Intersection ID: 48959	Main Street: FRANKLIN_SQUARE_RD	Cross Street: PERRY_JUNE_AV	Location:	SE
ADA ID: B66860B673F6	Ramp Type: Perp	Initial Pass/Fail: Pass	Overall Compliance: No	Severity Score: 20.25

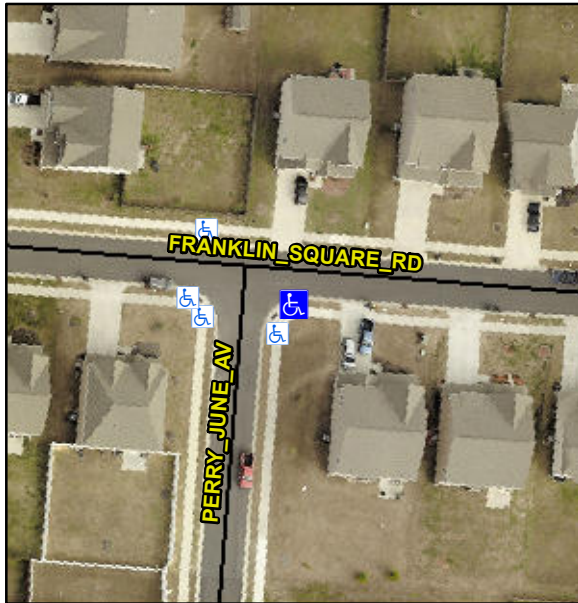
**Not Found, R305.2, R302.7.2,
R304.5.4**

**Remove & Replace Entire Ramp.
Remove & Replace Gutter.**
